## **Nokia FlexiHopper and FlexiHopper Plus antenna changes**

**Technical Note  
No. 95 version 1.0**

## TN 95 NOKIA FLEXIHOPPER AND FLEXIHOPPER PLUS ANTENNA CHANGES

*Picture 2: Single polarization 0.3m (upper left) and single polarization 0.6m (upper right) antenna with FlexiHopper microwave radio. Below the old 0.3m (bottom left) and 0.6m (bottom right) antennas are shown with Nokia FlexiHopper microwave radio.*

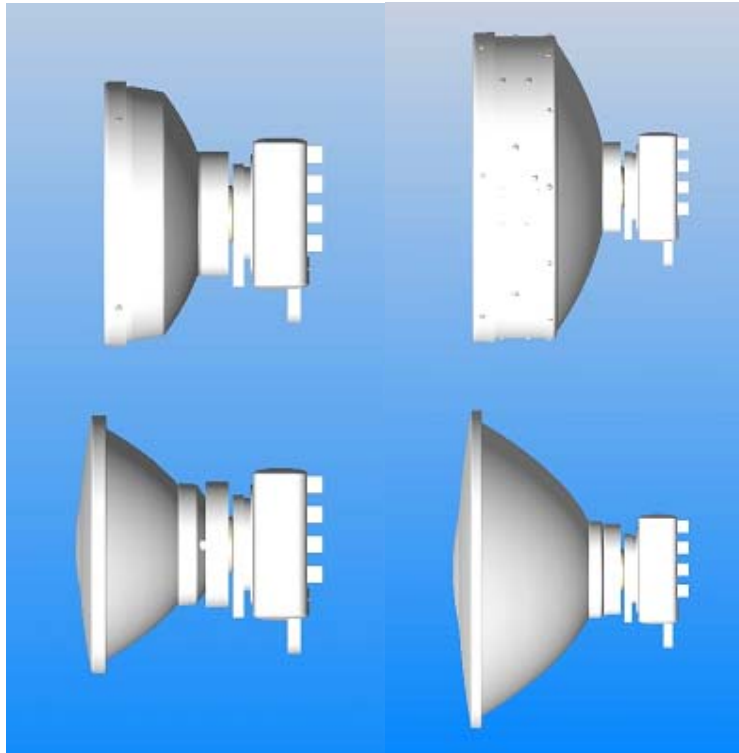
Mechanical changes in single polarization antennas:

- Outlook is a bit different since the reflector design has changed
- Do not cause changes to antenna installation procedure
- Antennas have new universal interface design for Nokia FlexiHopper (see pictures 1.-2.)
